Centerville Road Bridge No. 425 Rehabilitation

NOTICE TO PROSPECTIVE BIDDERS

ADDENDUM NO. 4 Prospective bidders and all concerned are hereby notified of the following changes in the Plans, Specifications, Proposal and Distribution of Quantities for this contract. These changes shall be incorporated in the Plans, Specifications, Proposal and Distribution of Quantities, and shall become an integral part of the Contract Documents.

TITLE OF SKETCH
REHABILITATION OF
CENTERVILLE ROAD BRIDGE NO. 425
SEQUENCE OF CONSTRUCTION

SKETCH NO.
1

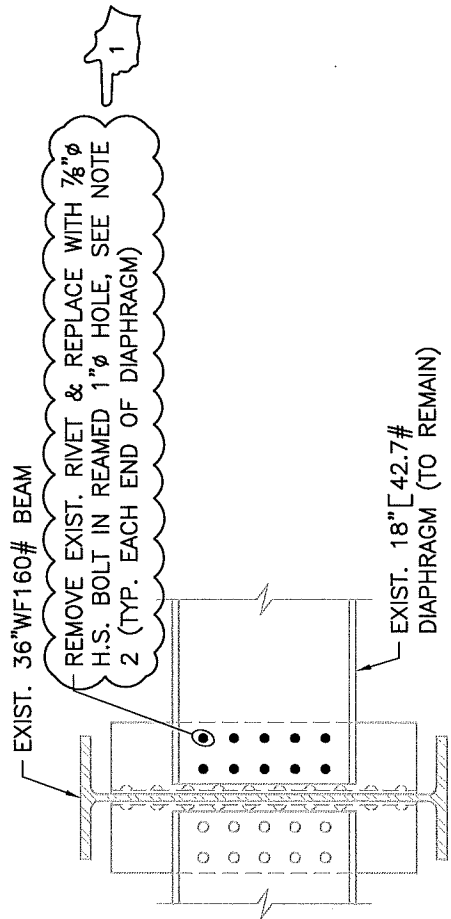
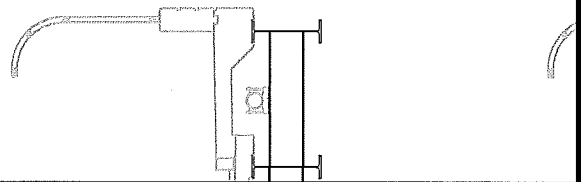
1. Sheet No. 8 - Sequence of Construction

Revise Sheet No. 8(R-1) as shown on Sketch No. 1(R-2) attached to this Addendum No. 4. Staged Construction Note No. 7 has been revised

6. THE ENTIRE LENGTH OF THE ASPHALTIC EXPANSION JOINTS AT THE ABUTMENTS SHALL BE PLACED AFTER PLACEMENT OF THE FINAL LAYER OF HOT MIX ASPHALT.
7. THERE ARE ITEMS OF WORK NOT AFFECTED BY THE STAGES OF CONSTRUCTION SHOWN HEREIN. THESE ITEMS INCLUDE, BUT NOT LIMITED TO, HIGHWAY APPROACH WORK, INSTALLATION OF ELASTOMERIC BEARING ASSEMBLIES, AND CLEANING & PAINTING OF THE EXISTING STRUCTURAL STEEL.
